August 20, 2018
BOARD OF COUNTY COMMISSIONERS
ORANGE COUNTY, FLORIDA
Addendum No. 1, IFB Y18-789-EB
BARBER PARK PLAYGROUND IMPROVEMENTS

Bid Opening Date: August 30, 2018

CONSTRUCTION PLANS FOR ORANGE COUNTY PARKS & RECREATION BARBER PARK PLAYGROUND IMPROVEMENTS DISTRICT NUMBER 3 ORANGE COUNTY, FLORIDA

SHEET NUMBER
C. 4
OF 19 SHEETS

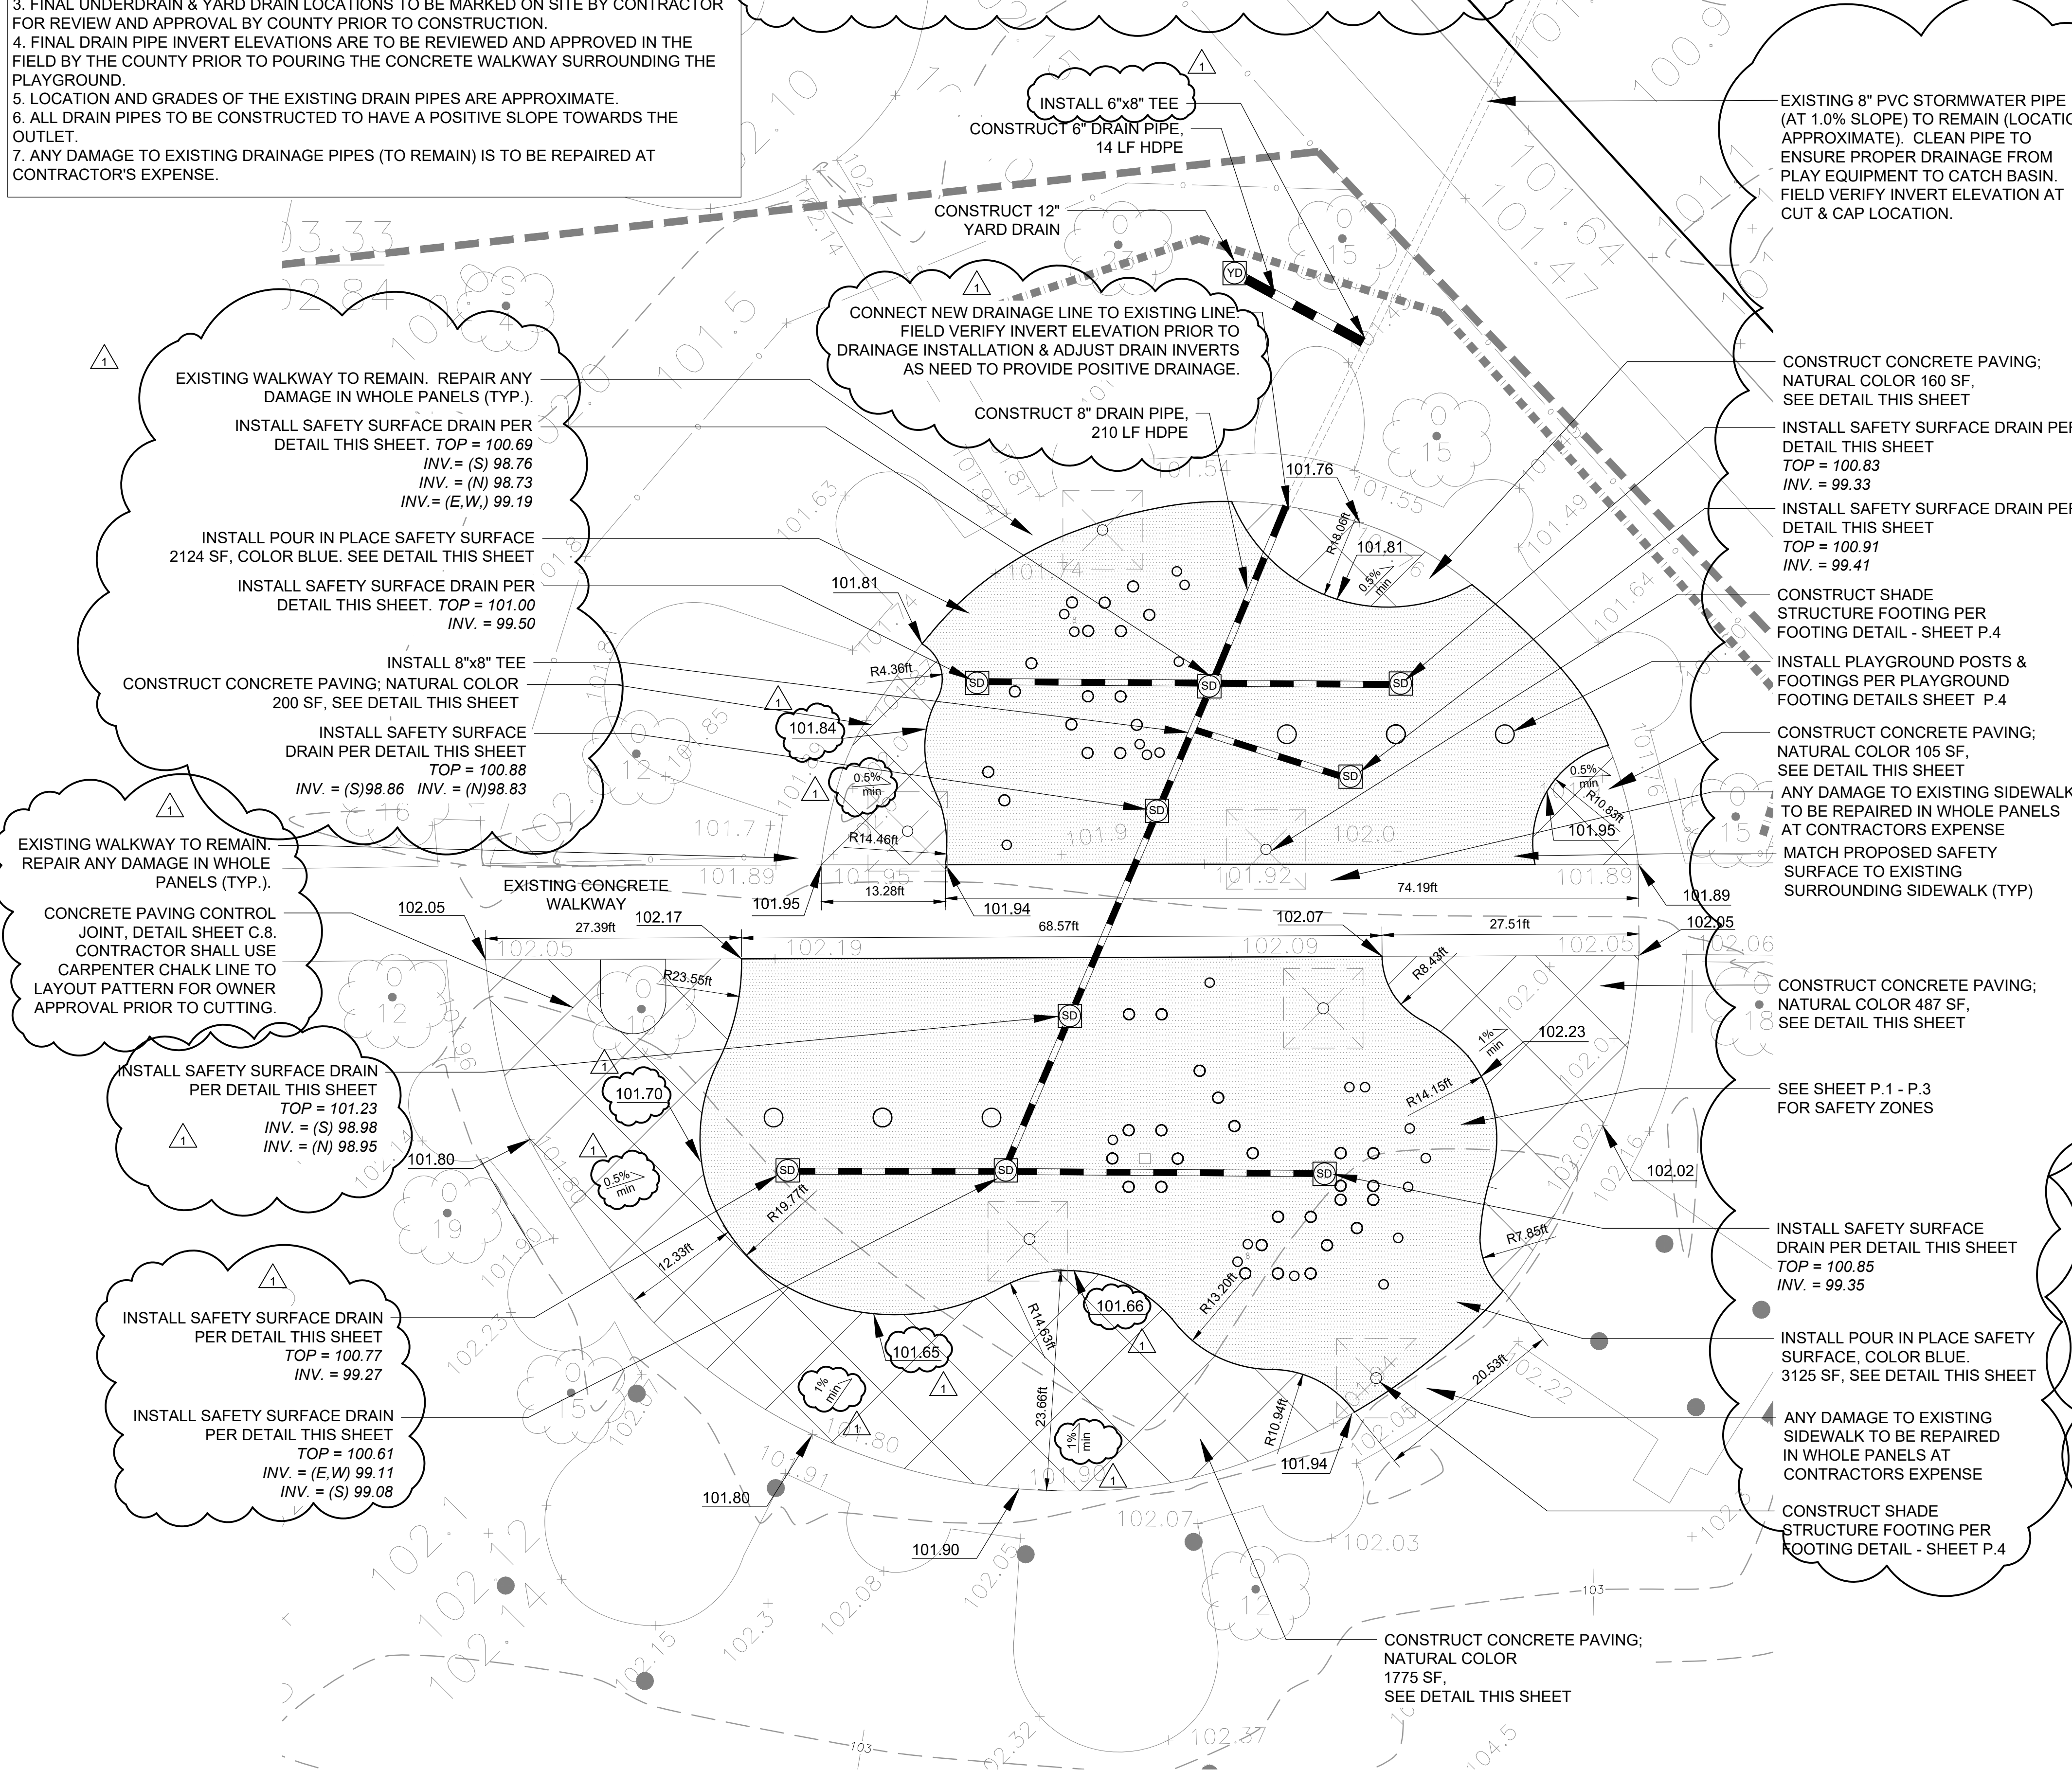
- Title block revision for Addendum #1 – no other changes.
- Sheet C.4 Demolition Plan – Playground dated 8/17/18
 - Fence removal note revised. All fencing located outside of the existing playground safety surface is to remain. All fencing located within the existing playground safety surface area is to be removed.

- All playground equipment and shade structures and all associated footings located within the existing playground safety surface area are to be removed.

- All existing playground safety surface and associated concrete base slab, drains, and pipes to be removed.
 - All repairs to existing concrete walkway to be replaced in whole panels.

- Contractor to locate and cut and cap existing drainage pipe. Contractor to clean existing drainage line prior to reconnecting to new playground drainage pipe.

- Note to bidders removed from top left corner of sheet.
 - 'Demolition Plan Keyed Notes' revised.
 - Concrete pad at north end of playground to remain.

DEMOLITION PLAN - PARKING AREA
ADDITIVE ONE

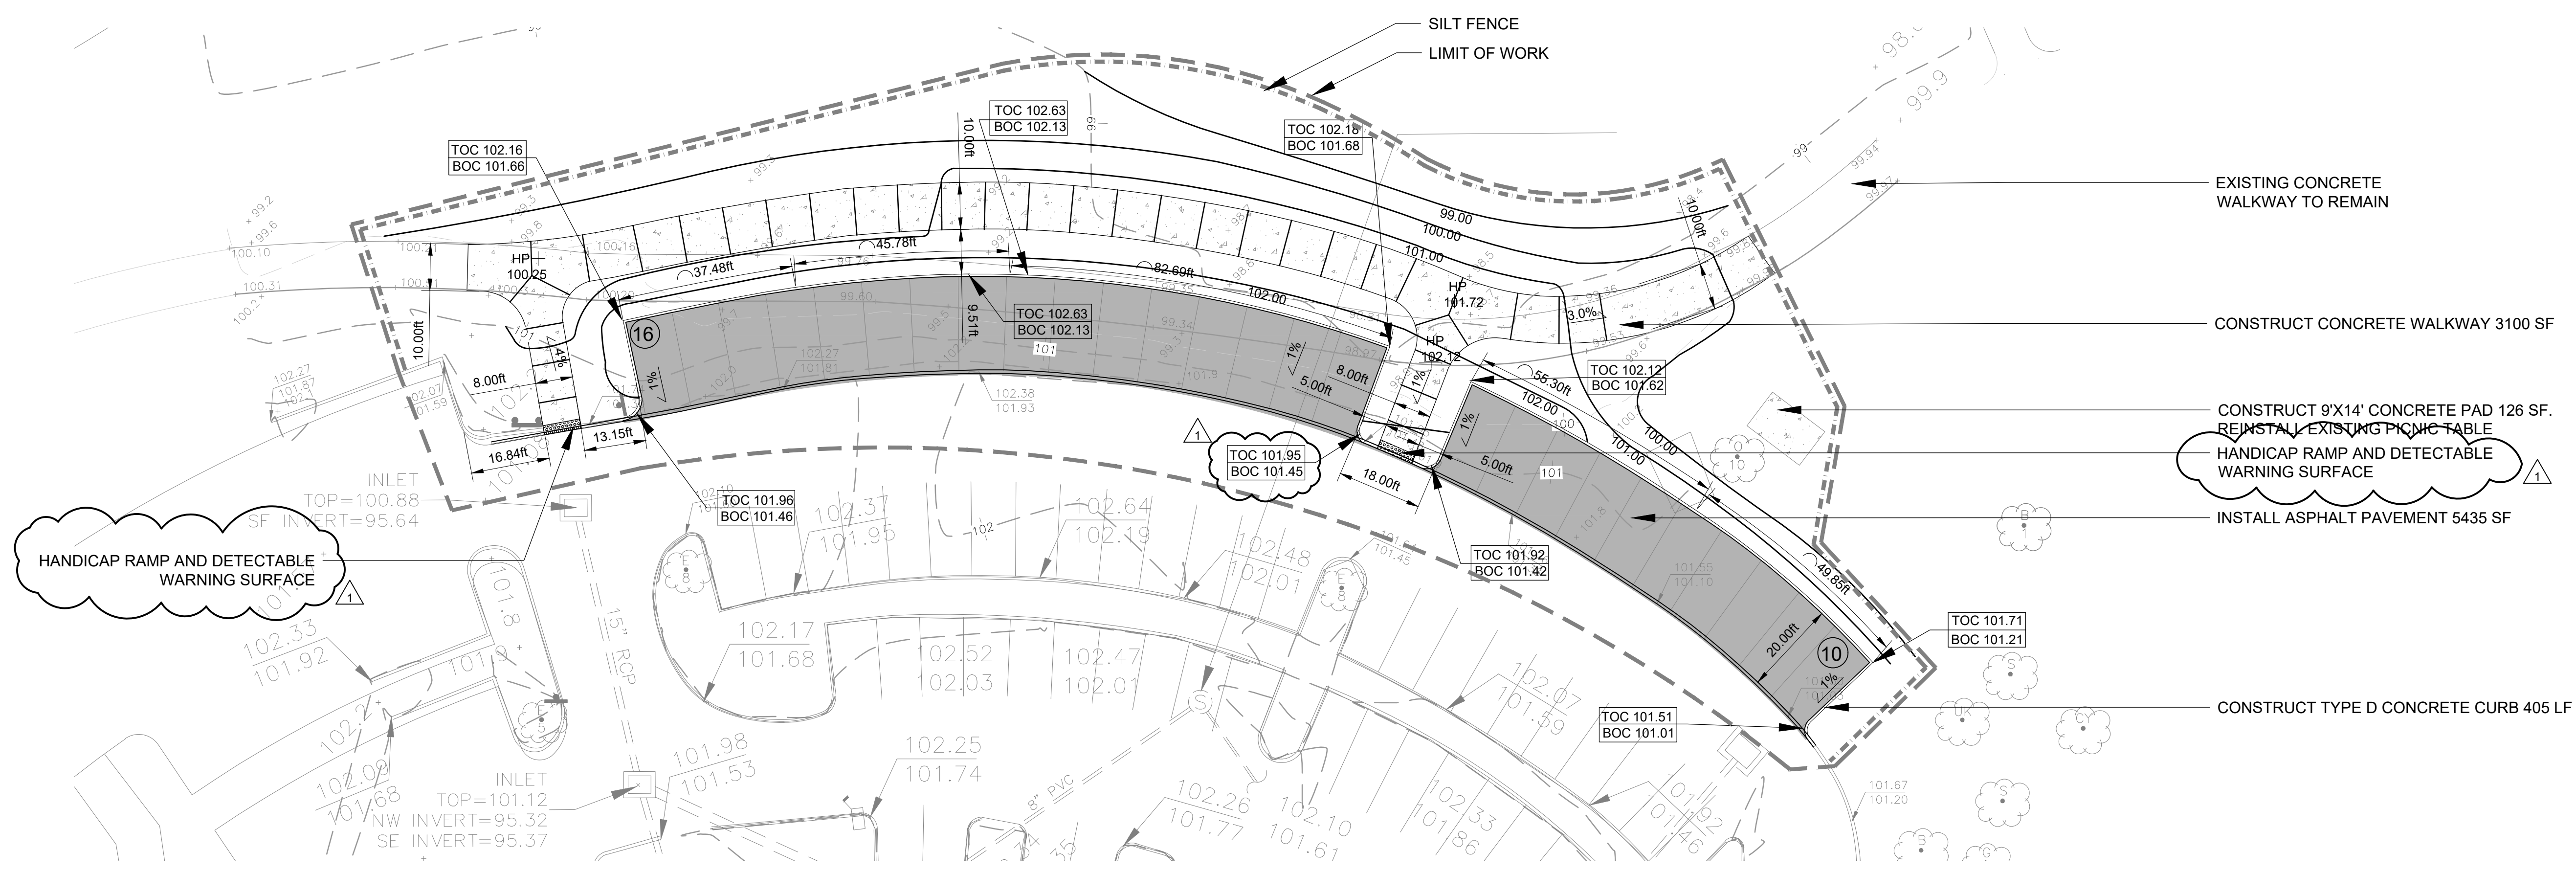
- Proposed concrete walkway at south end of playground revised to be sloped towards safety surface.
- Sheet C.6 Demolition Plan – Parking Area Additive One

- Existing concrete walkway note revised
- Sheet C.7 Grading Plan – Parking Area Additive One
 - ADA detectable warning surface graphic added where sidewalk meets parking area.

**GRADING PLAN - PARKING AREA
 ADDITIVE ONE**

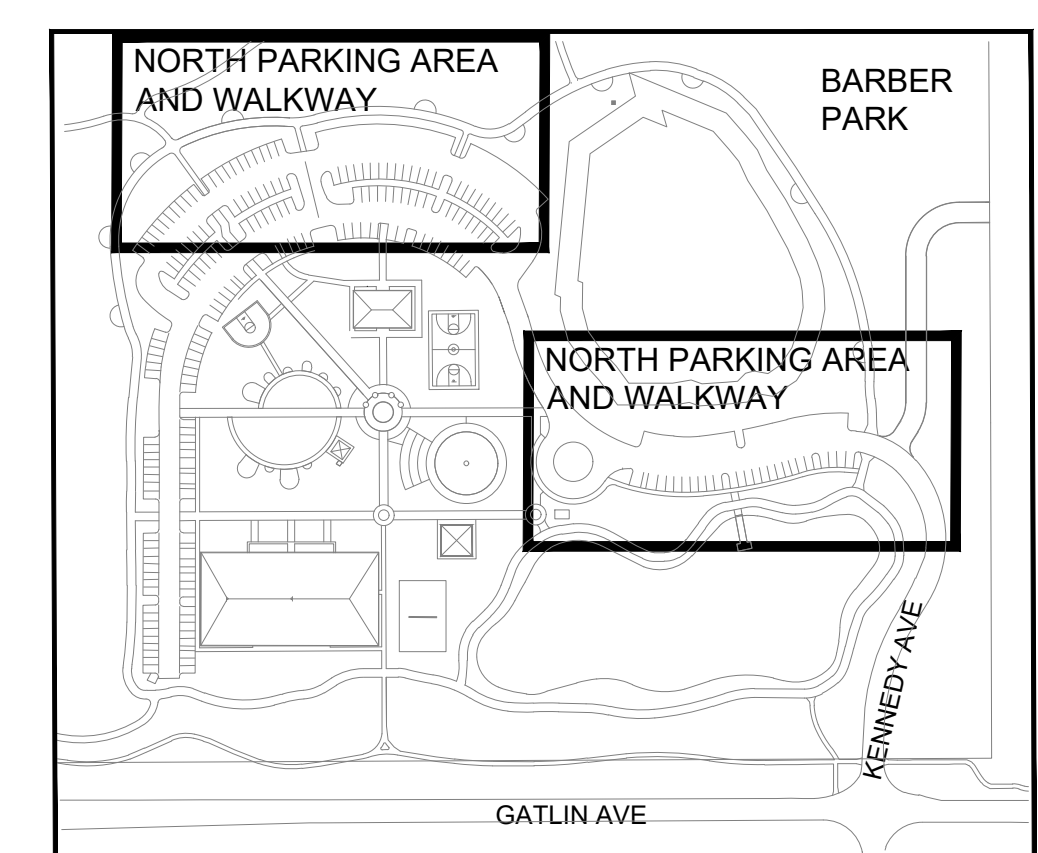
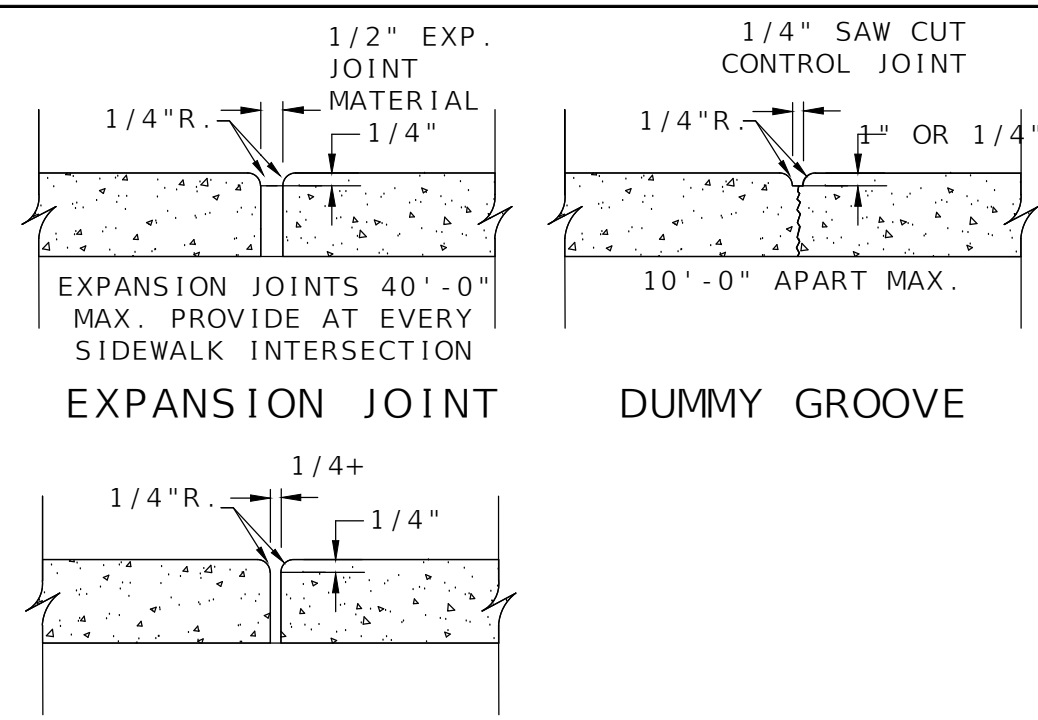
- Bottom of Curb elevation revised.
- Sheet C.8 Details - Construction
 - Detail #2: ‘EPDM Typical Safety Surface Wear Course Application’ revised.
- Sheet P.1 Playground Components
